## ***Interactive comment on “Fast NO<sub>2</sub> retrievals from Odin-OSIRIS limb scatter measurements” by A. E. Bourassa et al.***

**A. E. Bourassa et al.**

Received and published: 27 February 2011

Fig. 1. Revised Figure 5

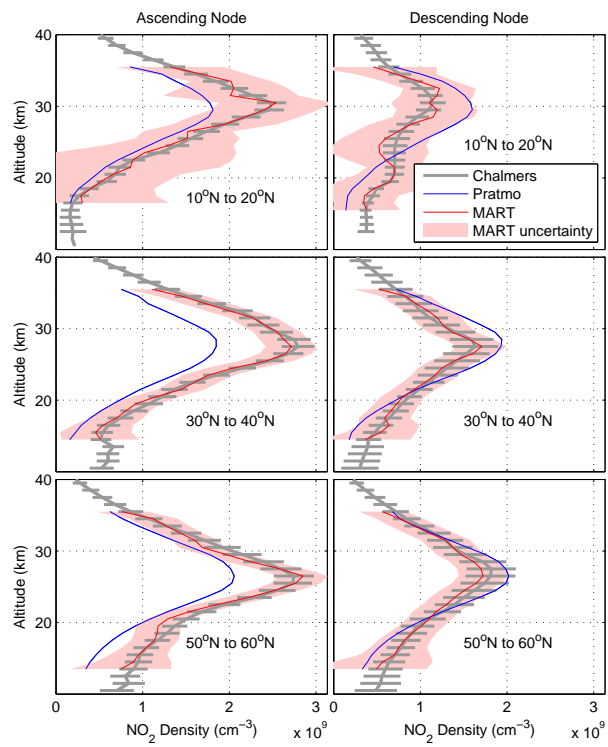
1. There is no discussion whatsoever about the error estimates of the new nor the official NO<sub>2</sub> product.

2. Fig 5. Instead (or additionally) of the zonal means, the authors should compare individual profiles and plot the mean/median (and deviation) of the individual relative differences for different latitudes/nodes.

The figure below is a revision of Figure 5, which now includes the precision of the new MART retrieval (in the red shading) in addition to the error estimate from the official NO<sub>2</sub> product (in gray bars). The error bars shown on the profile are the average uncertainty for each of the average profiles (and not the error in the average profile). Thus these error bars show the typical error for a single retrieved profile in each of the latitude bins. As expected, the uncertainty in the MART retrievals is systematically larger than that in the official product. However, for mid and high latitudes where the signal to noise is high due to the smaller solar zenith angles at the tangent point, the MART error bars are much less than a factor of two larger those of the official product. However, in the tropics where the signal to noise is decreased, the MART uncertainty can be several times larger than the uncertainty in the official product.
